From: Felicity Macqueen
Sent: 4/12/2023 1:05:06 PM
To: Council Northernbeaches Mailbox
Subject: TRIMMED DA2023/1395
Attachments: DA20231395 Submission - Macqueen.pdf;

As the owners of 12 Cliff Road, Collaroy – located to the immediate east of the subject site - we wish to raise the following matters and recommend that the proponent be given an opportunity to make amendments to the current scheme to address these critical issues.

Figure 2: Section AA of Architectural plans - red hatching showing non-compliance with height

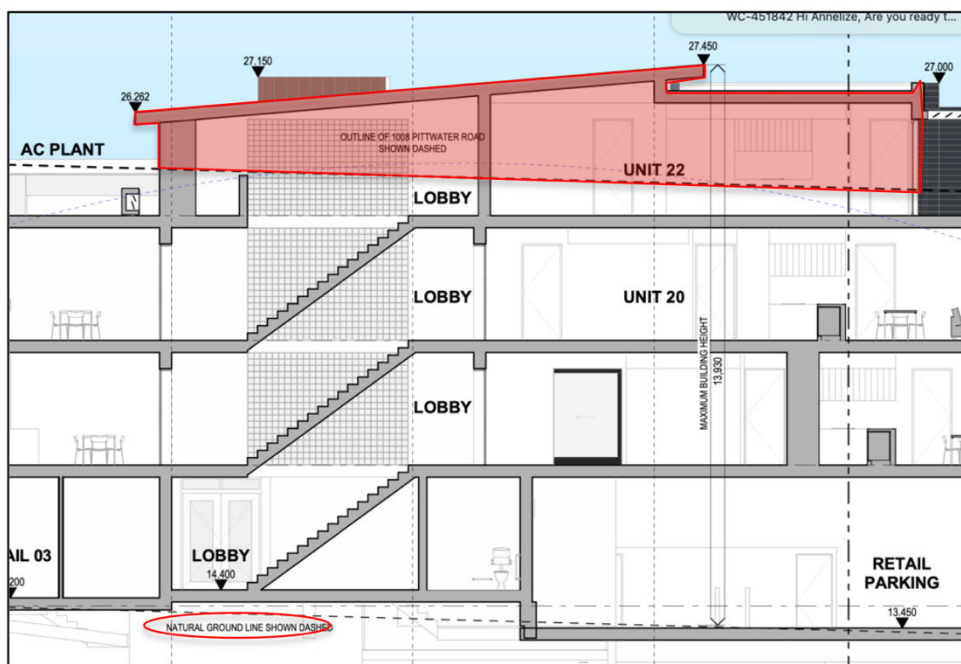
2. Violation of Storey Limits

The intended construction, standing at four storeys, exceeds the local Development Control Plan's (DCP) allowance of three storeys, compounding concerns raised by the height violations, as outlined in the first point.

The Council's Design + Sustainability Advisory Panel Meeting Report (26 October 2023) recommends:

'The location of the site next to R2 on the east requires careful consideration of its impact on the smaller scale buildings. While the scale of the building presents well to the street on Pittwater Road, it is more imposing to the residents in the R2 zone to the east. Consideration should be given to moving some of the bulk towards the street.'

We agree with Council that the scale and mass of the build has a huge impact on our property (a single-storey home) and believe the bulk of the development should be moved towards Pittwater Road which does not affect residents to the east as detrimentally.

Figure 3: Visible massing

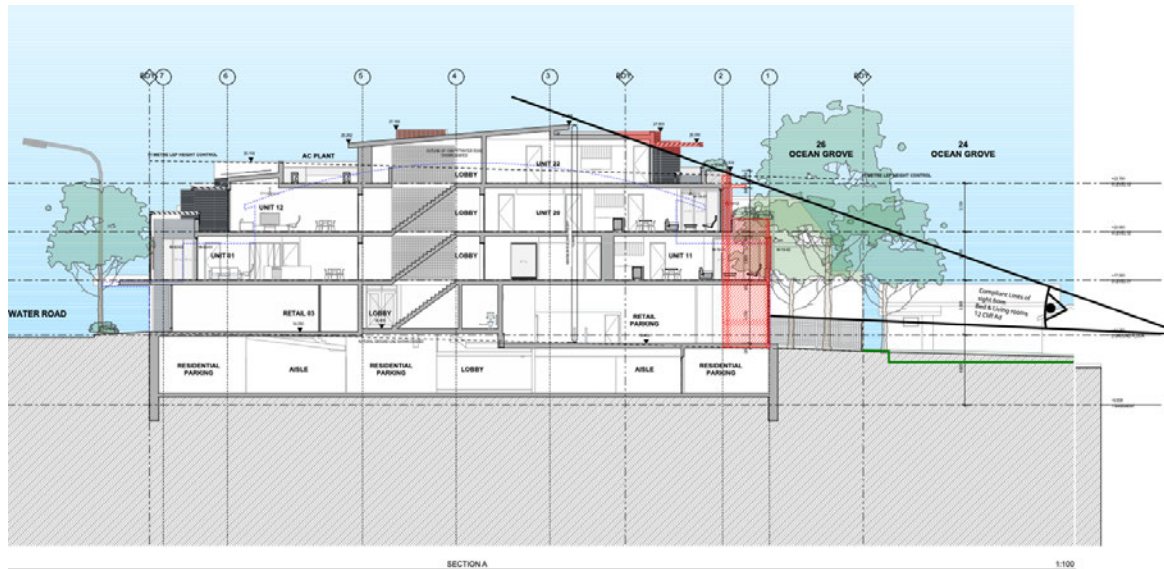
3. Encroachment & Privacy Concerns

Towards the rear, the building encroaches 3 meters closer to the boundary than specified in the planning instruments, amplifying its imposing presence beyond acceptable limits.

Figure 4: Overlooking potential

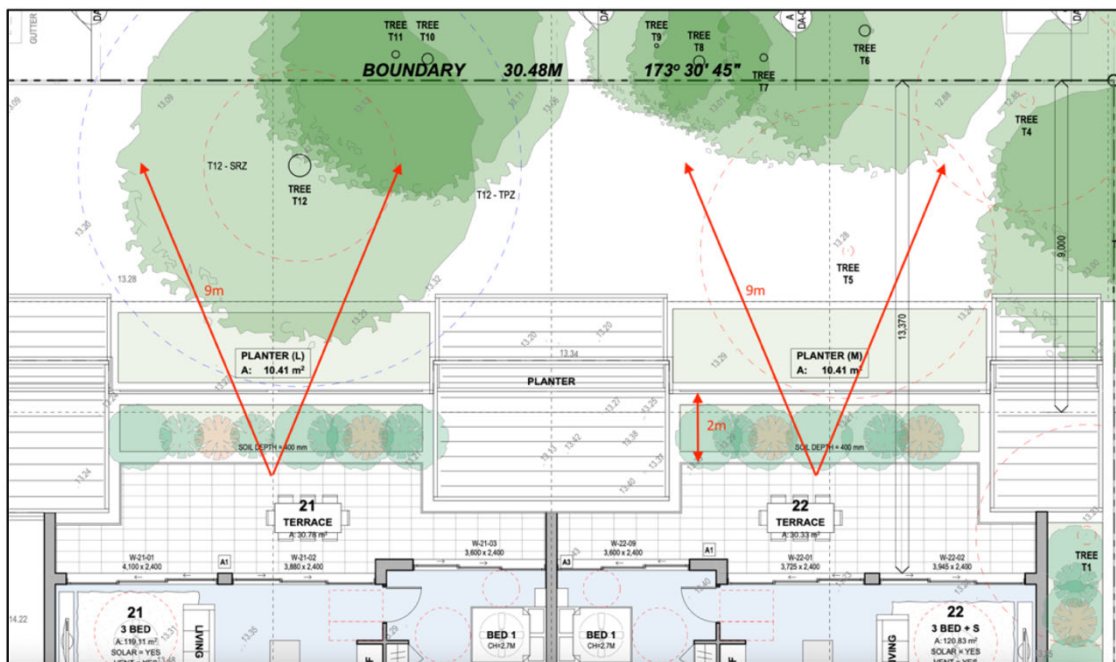
The three key points outlined above raise serious concerns regarding the privacy of our property, with the proposed development having an intrusive view into our children's bedroom and lounge/kitchen as well as our backyard.
